Interactive comment on “TerrSysMP-PDAF (version 1.0): a modular high-performance data assimilation framework for an integrated land surface–subsurface model” by W. Kurtz et al.

General comments

Fig. 1. Absolute average error of soil water content for open-loop (left) and assimilation (right) at a depth of -65 cm from April–June 2013.

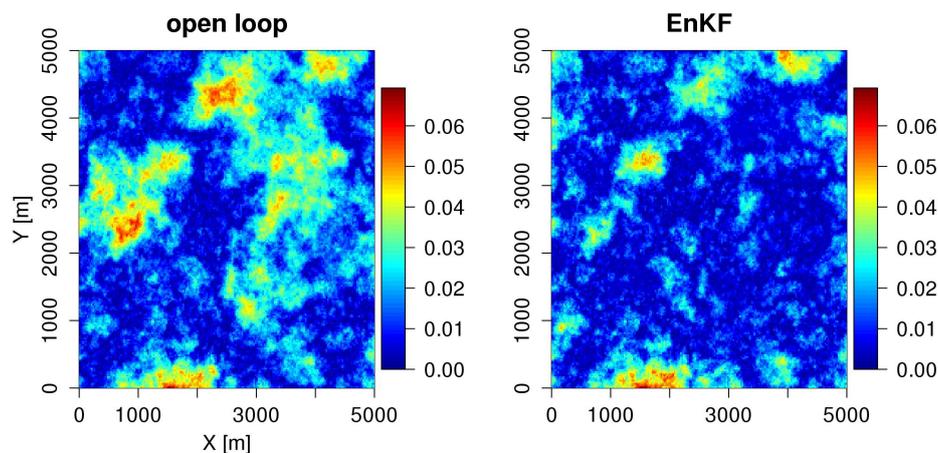
14. Figure 10 There is a phantom line at y = 1500 m. Not sure if this is a pdf rendering problem.

Reply: Unfortunately, we found that there was a problem in the calculation of the AAE fields (time shift between the reference and the ensemble mean of soil moisture). Based on the new calculations, the discontinuity at y=1500m vanished and the background AAE value of 0.03 was decreased to zero (see Fig. 1 below). Other results were not affected by this calculation error.
